1 **Point-by-point response to the reviews**

2  
3 **Referee 2**

8  
9 In this paper, Li *et al.* investigate the sensitivity of dust in the CESM2-CAM6.1 climate model to  
10 various parameterized processes: the emissions scheme, the dry deposition scheme, the fixed  
11 geometric width of the coarse mode, and the assumption of spherical/aspherical particles. Using  
12 a wealth of validatory observations and many simulations, they find that changing dust emissions  
13 and the coarse mode width have the greatest impact on the dust metrics, followed by the dry  
14 deposition scheme and then asphericity. They also propose a new version of CAM (CAM6.α)  
15 which improves on many dust metrics relative to CAM6.1 and incorporates some of the listed  
16 process changes.

53  
54 Suggested simulations:

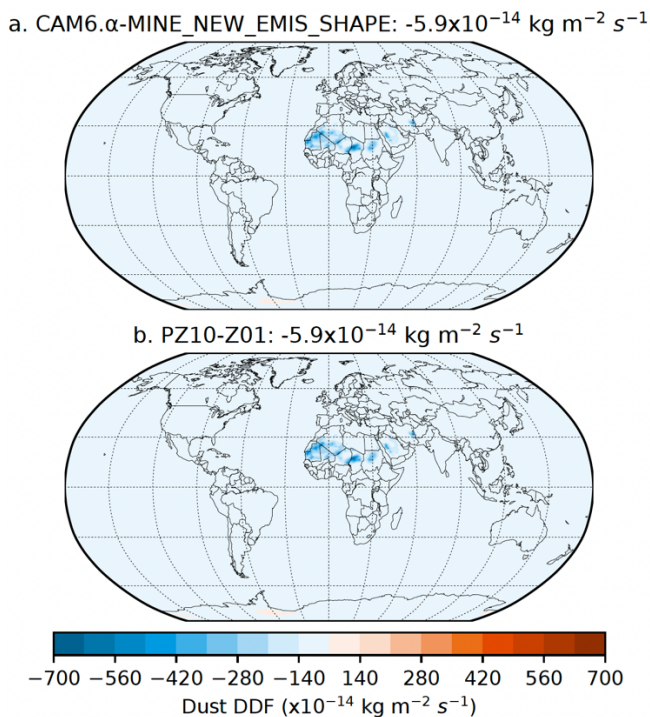
40 Firstly, I think that the simulation design is incorrect for exploring the sensitivity of dust to the  
41 altered processes. For example, the new dry deposition scheme is only tested in conjunction  
42 with the other altered processes (CAM6.α and CAM6.α\_MINE) and never on its own. Conversely,  
43 the new emissions scheme is tested by itself for both BULK and MINE dust models, whilst the  
44 size and shape of the particles are tested in conjunction with the new emissions scheme but  
45 using BULK and MINE dust respectively. In short, it's very difficult to attribute the impacts on the  
46 dust metrics to the individual processes.

47  
48 I would suggest concentrating on either the BULK dust scheme or the MINE dust scheme, unless  
49 you plan to directly compare them. The study would be much cleaner if the processes were  
50 tested in isolation using either BULK or MINE and then compared to CAM6.1 (see Table below).  
51 In its current form, it is very difficult to disentangle which dust impacts emanate from which  
52 altered process.

55  
56  
57 In summary, I would highly recommend that the authors run further simulations with each of the  
58 processes applied separately as the current simulation design is not conducive or particularly  
59 supportive of the results presented in the manuscript.

60  
61 This is a similar comment to what the first Reviewer raised. Below we paste our reply to the  
62 comment by Reviewer # 1 (Line 41-169 in that report) as a response in the text.

63  
64 There are a couple of different methods to estimate the effect of each development, such as the  
65 one we used and the one the reviewers suggested. Strictly speaking, either method cannot  
66 totally exclude the possible influence of the parametrizations that had already been included and  
67 can affect the dust cycle modeling in the base model, such as the advection scheme and cloud  
68 processing. The reason is that there likely exists a nonlinear “interaction” between the existing  
69 parameterizations and the newly introduced one, which seems weak though. We acknowledge  
70 that adding one by one seems clearer than the original experiment design, but it requires more  
71 simulations and thus more computational resources while yielding a similar estimate of the

105 **Fig. R2.** Surface dust emissions (a; global annual mean=2891 Tg) and deposition fluxes (b;  
 106 global annual mean=2893 Tg) simulated by CAM6.α and their differences (c and d; both global  
 107 annual mean=22 Tg) between MINE\_CAM6.α and CAM6.α.  
 108  
 109

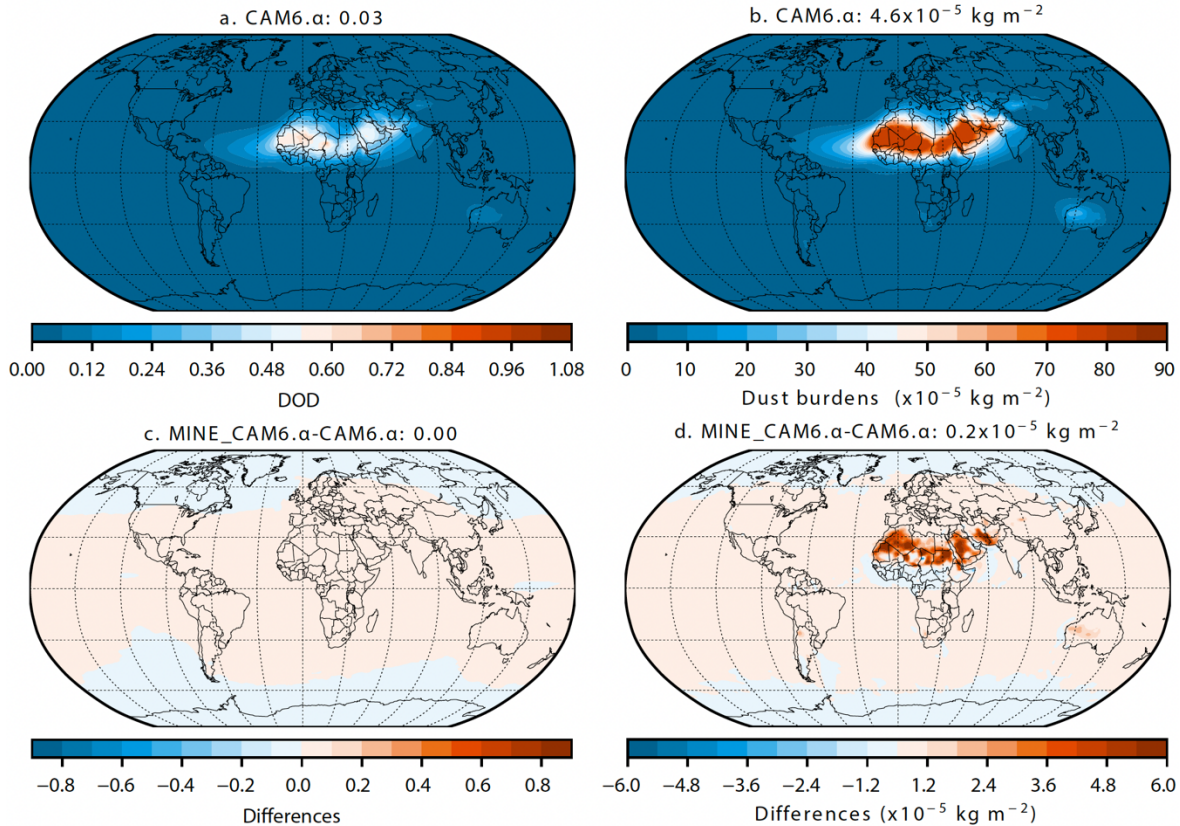
83  
84 The BULK runs were constructed to investigate how the mistakenly set dust size distribution  
85 influences the dust cycle modeling and the estimate of dust DRE. This inappropriate size  
86 distribution has been employed in studies using the officially released BULK CAM6 and not in  
87 any study using the dust-speciated CAM. So, we do not have a good reason to perform size  
88 sensitivity tests in the MINE runs. What's more important is that quantifying the impact of  
89 individual processes, based on the base CAM6.1 that uses an inappropriate dust size distribution,  
90 seems not that meaningful: it makes more sense to make such quantification using models with  
91 the "correct" size distribution. That is why in all the MINE runs designed for that purpose we  
92 revert the narrow coarse-mode size distribution to the broad one. Also, following the reviewer's  
93 design would change little to the results obtained from our experiments on the dust cycle

94 modeling. This is because the offline dynamics and the dust tuning employed ensures quite  
95 similar dust cycles modeled by BULK and MINE with different developments (**Fig. R2** and **Fig.**

96 **R3**), if the size distribution is also set identical, since the sum of the mass fraction for each of the  
 97 eight minerals always equals unity. We had pointed this similarity out in our originally submitted  
 98 manuscript: “It is worth noting that with the dust tuning applied toward the similar global mean  
 99 DOD  $\sim 0.03$  the modeled dust cycle (i.e., burdens, concentrations, loadings, deposition fluxes)  
 100 would be similarly comparable between the bulk and speciated dust models using the same  
 101 offline dynamics and dust size distribution”. Repeating the set of simulations using BULK instead  
 102 to quantify the impact of each altered process would then yield similar results that we presented  
 103 in the manuscript.  
 104

110 **Fig. R3.** The same as **Fig. R2** but for DOD (a: global annual mean=0.030 and c: global mean  
 111 difference=0.001) and dust burdens (b: global annual mean of dust mass=24 Tg and d: global  
 112 mean difference≈0 Tg), respectively.  
 113

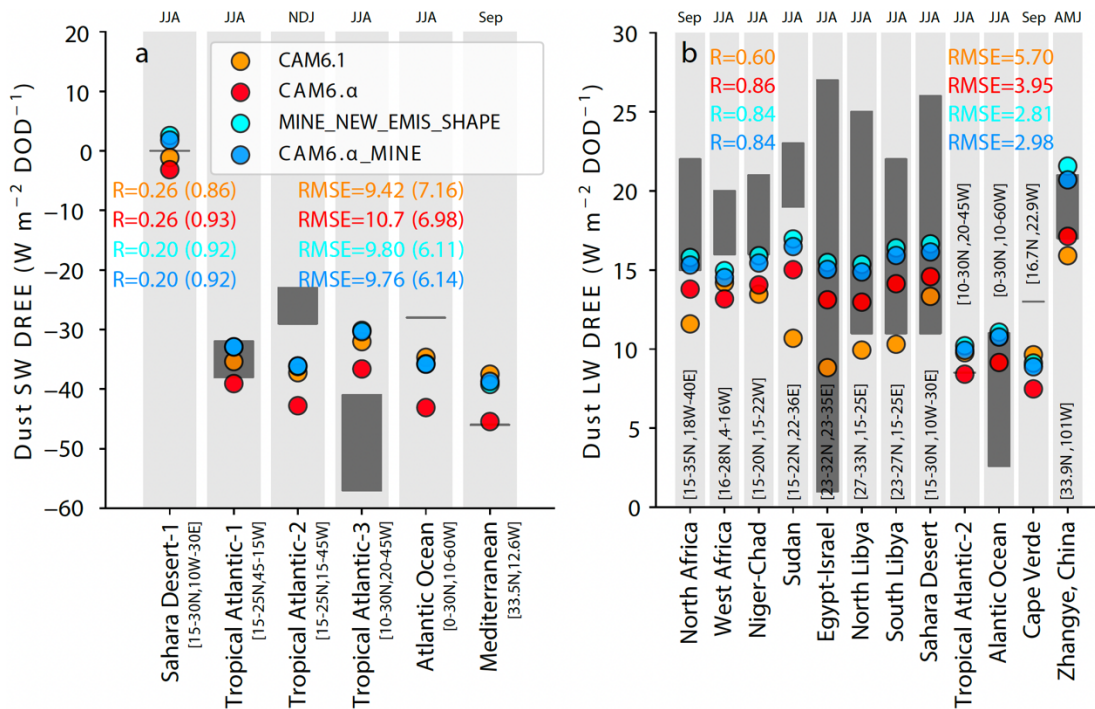
642 [L285] *“Therefore, we state the difference in the dust DRE and DRE efficiency estimate in Sect.  
643 6, but do not document the comparison of dust loadings/deposition/DOD between the bulk and  
644 speciated dust simulations.”* – Avoiding comparing BULK and MINE seems like a massive  
645 oversight and is one of the first things I’d query as a reader. Does speciation between minerals  
646 improve the simulation compared to assuming dust as a bulk quantity? Simply saying that as the  
647 dust properties are different (of course they will be), this reduces comparability, is a little bit  
648 absurd and a bit of a cop out. I think this comparison should be made in a follow-on paper. To  
649 be honest, it doesn’t seem worth including the MINE simulations if they not appropriately  
650 analysed.

652 The dust speciation helps better reproduce the observed DRE efficiency improvements  
653 compared to without the speciation, as presented in the Section 4.3.1 (5.3.1 in the revised text).  
654 For non-optical variable, summing over the eight minerals gives the total dust

655 loadings/deposition/DOD similarly comparable to that from simulations without the dust  
 656 speciation. Per the suggestion of the reviewers, we added a new section “6. Bulk- versus  
 657 speciated-dust model” collecting information about the comparison between BULK and MINE  
 658 results that scattered in the text: s

675  
 676 Also, we added RMSE and correlation coefficient in the DRE efficiency plot as shown below.  
 677
